Safety Evaluation Report

related to renewal of the
operating license for the
Texas A&M University Research Reactor

Docket No. 50-128
License R-83

**U.S. Nuclear Regulatory
Commission**

Figure 17.1 FLIP fuel element spacing in the Texas A&M reactor core near transient rod

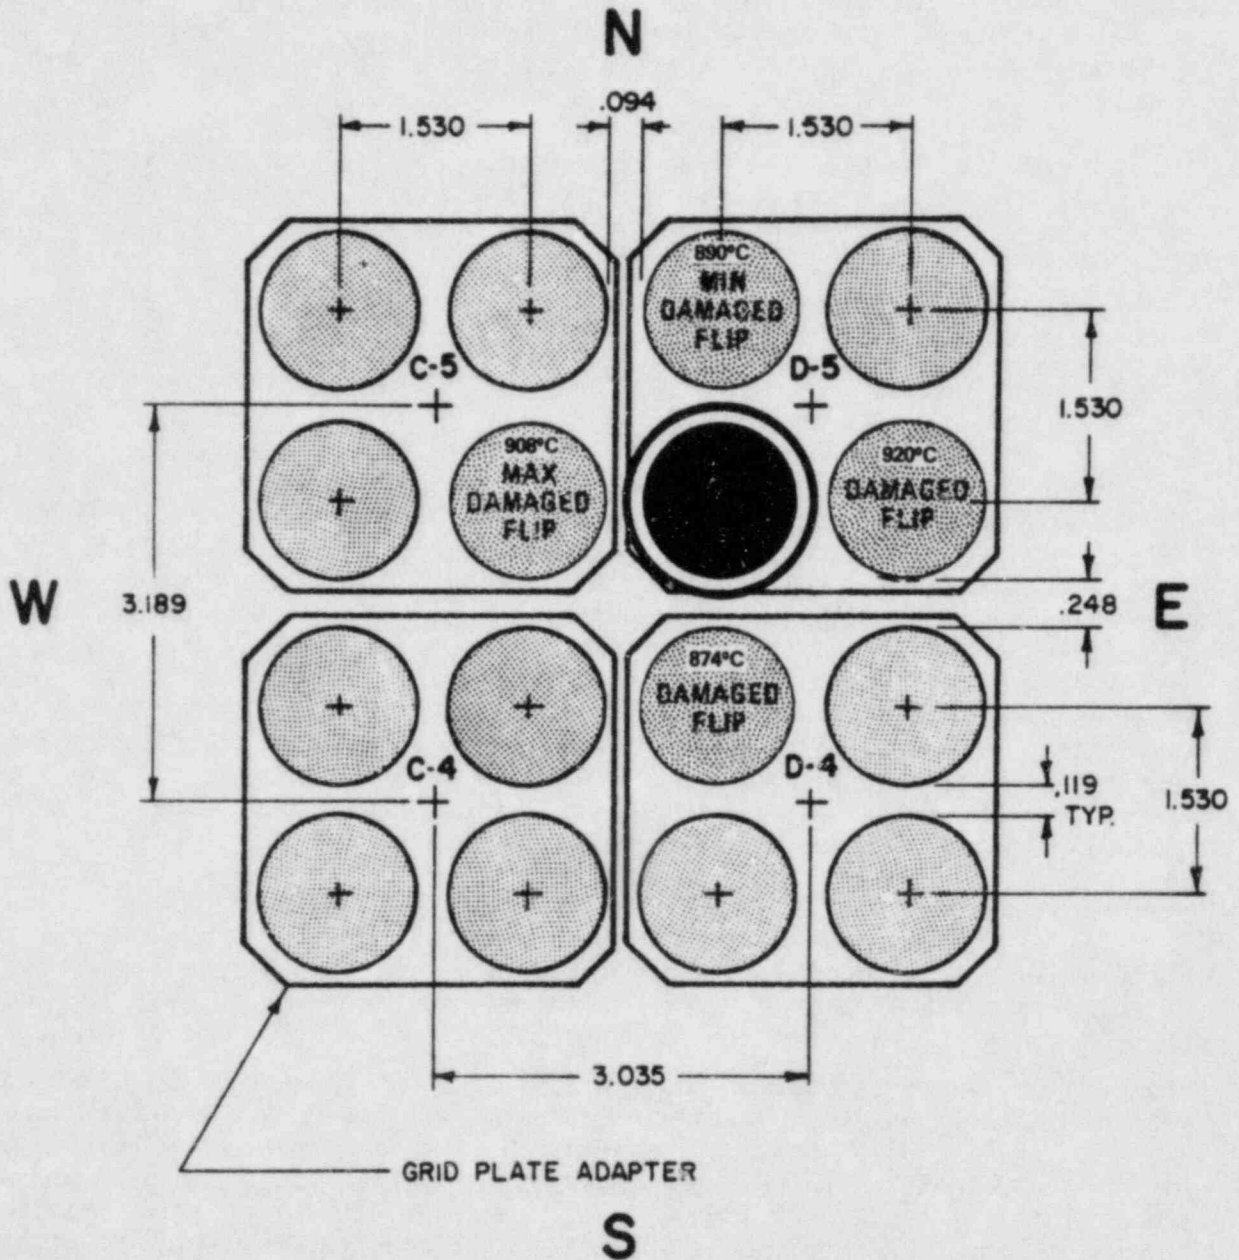
During a loading operation on September 27, 1976, three* damaged fuel elements were discovered in the core. Fuel element deformation but no cladding failure were noted (see Figure 17.1). A report on the discovery and preliminary analysis was submitted from the applicant to the staff on November 1, 1976. At that time it was determined that no valid conclusion concerning the cause of the damage was possible without metallographic examination of the damaged fuel elements. Argonne National Laboratory (ANL-West) had TRIGA-FLIP fuel and the necessary analytical facilities to perform these examinations. Because of delays as a result of hot cell modifications, the low priority of this project, and coordination of personnel from Texas A&M, Argonne National Laboratory, and General Atomics Company, it was several years before data were collected and the evaluation of the work completed. The final report was issued in December 1981 (GA-A16613) with the proposed damage mechanism receiving consensus from those concerned.

- (1) During continuous operation for long periods, there is hydrogen migration radially and axially from regions of higher temperatures to regions of lower temperatures. This produces local areas of high concentrations of hydrogen, which could be sources of high pressure at higher temperatures experienced mostly during long-term operations (see Figure 17.1).

Figure 17.2 Zirconium hydride phase diagram showing boundary determination

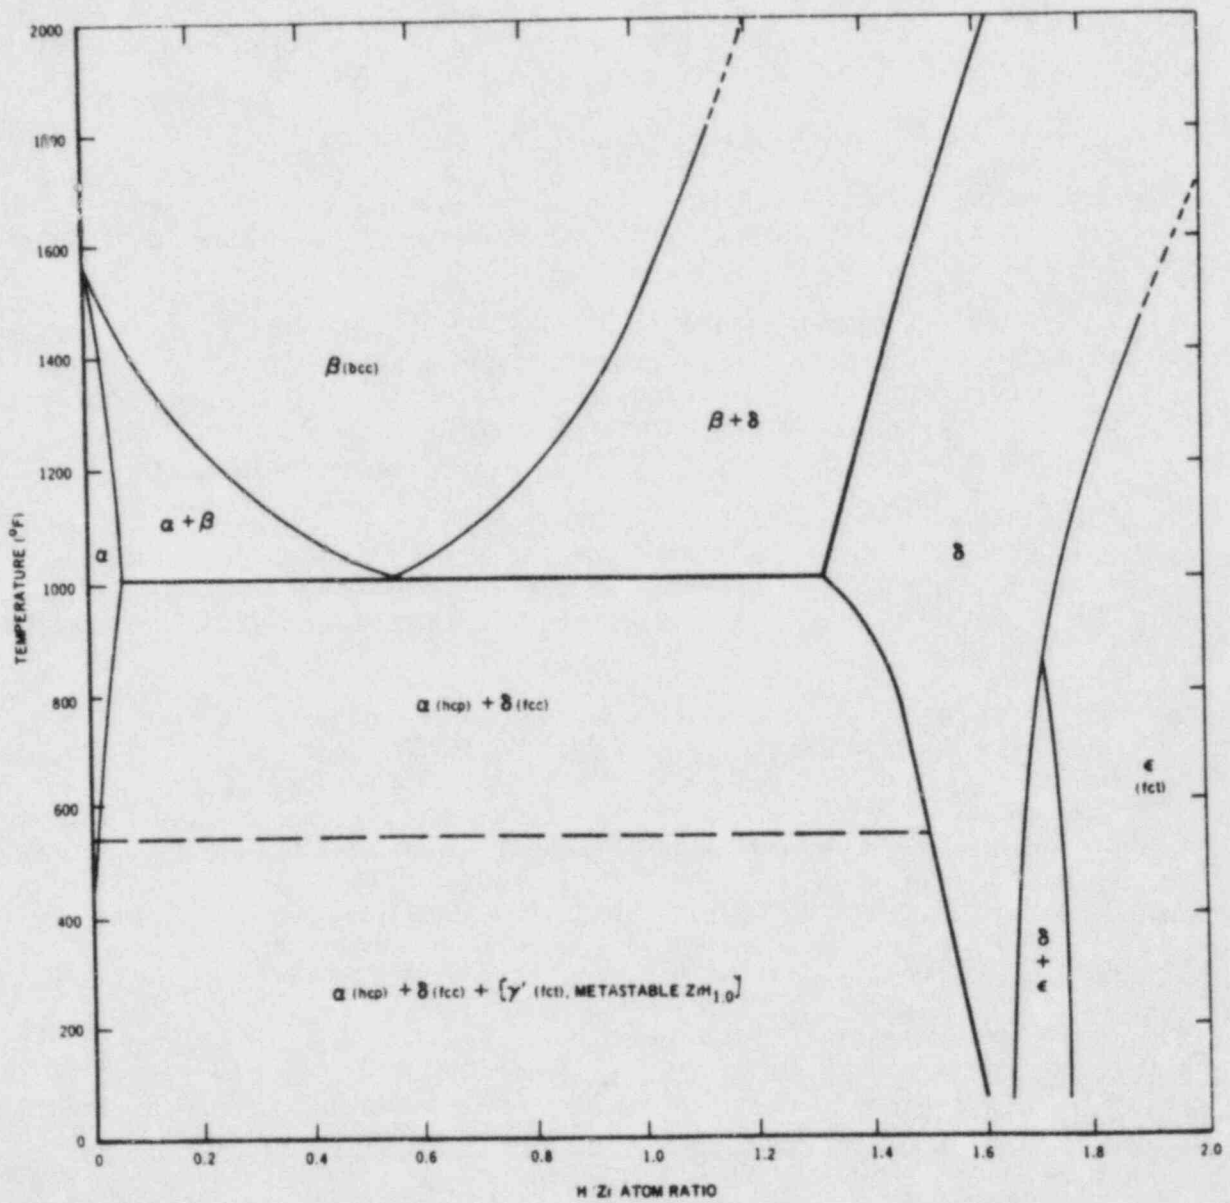
The damaged fuel elements were FLIP fuel, fabricated with a hydrogen-to-zirconium ratio of 1.6. This hydrogen-to-zirconium value was carefully selected to take advantage of several properties of zirconium hydride. Figure 17.2 reproduces a phase diagram of ZrH_x presented by Simnad (GA-4314, 1980). The diagram indicates that a hydrogen-to-zirconium atom ratio of 1.6 produces the delta phase and remains in this phase to well over 1,000°C. This avoids substantial volume changes resulting from phase transformations that occur at approximately 530°C at lower hydrogen ratios (GA-9064, 1970 and GA-6874, 1966). It also produces a material that exhibits very small density changes with varying hydrogen content (GA-4314, 1980). An additional advantage of the delta phase is that it has much greater creep strength than the beta phase. However, if the fuel is used
